# Minimax Ltd. (Relocated)

20 September 2021

# Observations

Column Layout plan

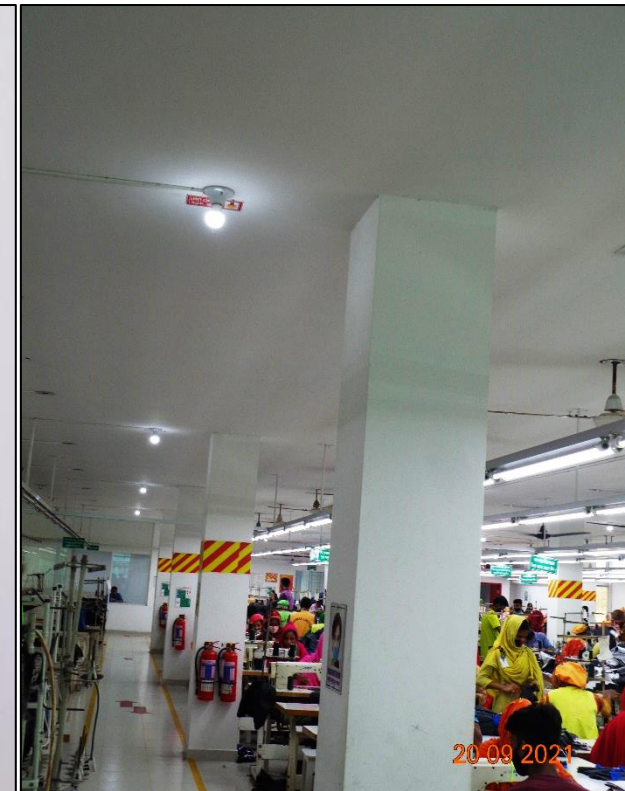
**Punching stress in flat slab exceeds  
normal design limit**

Cursory calculation indicates that the punching stress in flat slab of the highlighted area exceeds normal design limit. Considering 3 kPa live load on typical floor, 1.5 kPa on roof and equivalent concrete strength for brick chips, flat slab have been found stressed in excess of normal design limit. Factory Engineer to review design, loads and punching stresses in area identified above. Verify in-situ concrete strength by 100mm dia. cores from existing flat slab. Produce and actively manage a live loading plan for all floor plates within the factory considering floor capacity.

| Item No. | Observation                                                            | Recommended Action Plan                                                                                                                                                            | Recommended Timeline |
|----------|------------------------------------------------------------------------|------------------------------------------------------------------------------------------------------------------------------------------------------------------------------------|----------------------|
| 01       | Punching stress in flat slab exceeds normal design limit. (Building-1) | As part of Detail Engineering Assessment (DEA), factory engineer to review design, loads and punching stresses of flat slab.                                                       | 6-weeks              |
| 02       | Punching stress in flat slab exceeds normal design limit. (Building-1) | Verify in-situ concrete strength by 100mm dia. cores from existing flat slab.                                                                                                      | 6-weeks              |
| 03       | Punching stress in flat slab exceeds normal design limit. (Building-1) | Produce and actively manage a loading plan for all floor plates within the factory considering floor capacity.                                                                     | 6-weeks              |

Cover page of Detail Engineering Assessment report

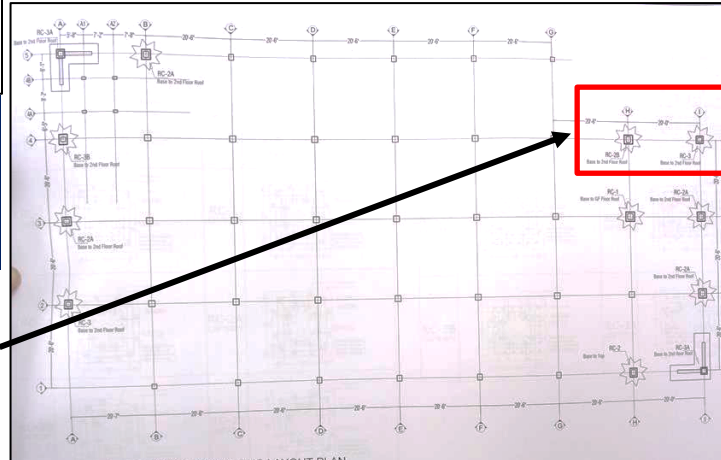
**DEA report needs to be reviewed by RSC**

As per recommendation of Detail Engineering Assessment (DEA), factory was required to complete the retrofitting works by strengthening the RC columns and construction of shear wall in corner of stair zone.

Retrofitting of these two column was not completed at 2<sup>nd</sup> floor as per retrofitting drawing.

These two column has not been retrofitted

Factory engineer is required to check the requirement of strengthening of these two columns and revise the Detail Engineering Assessment (DEA) report accordingly. Submit DEA report to RSC for further review.

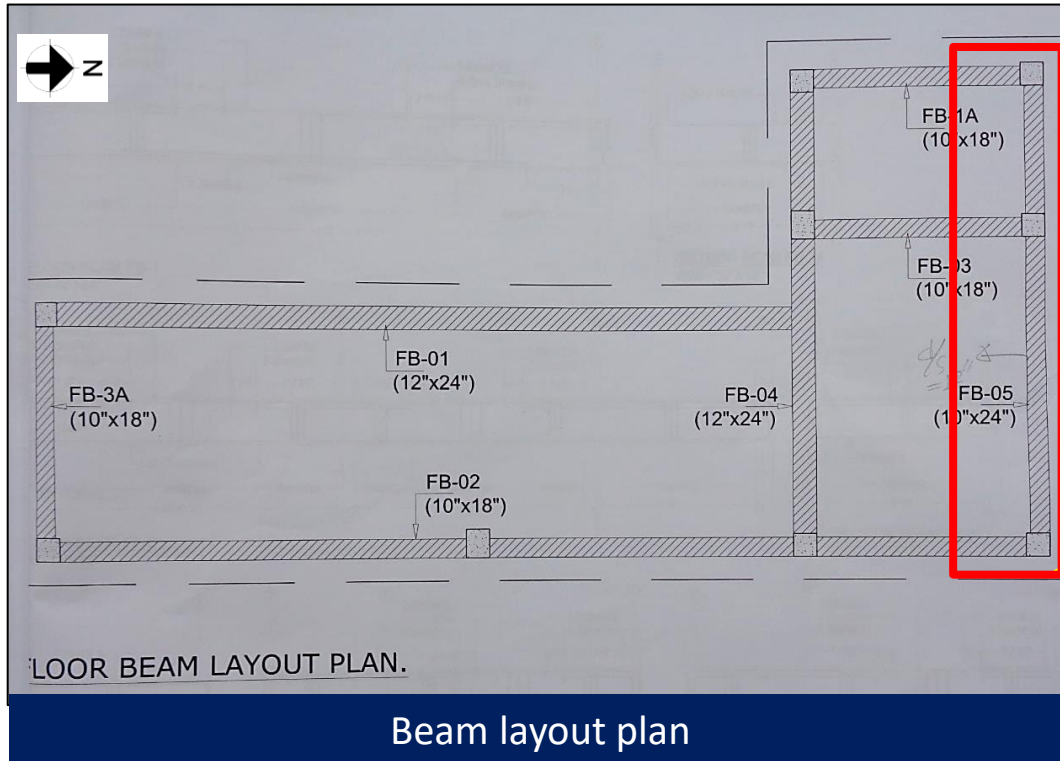
Down-stand depth of the beam was found 300 mm

During inspection, down-stand depth of the beam was found 300 instead of 465 mm (considering 135 mm slab thickness).

Factory engineer is required to survey the whole structure and update the as-built drawing in compliance with the article 1.9.1 of BNBC 2006 (part-6)
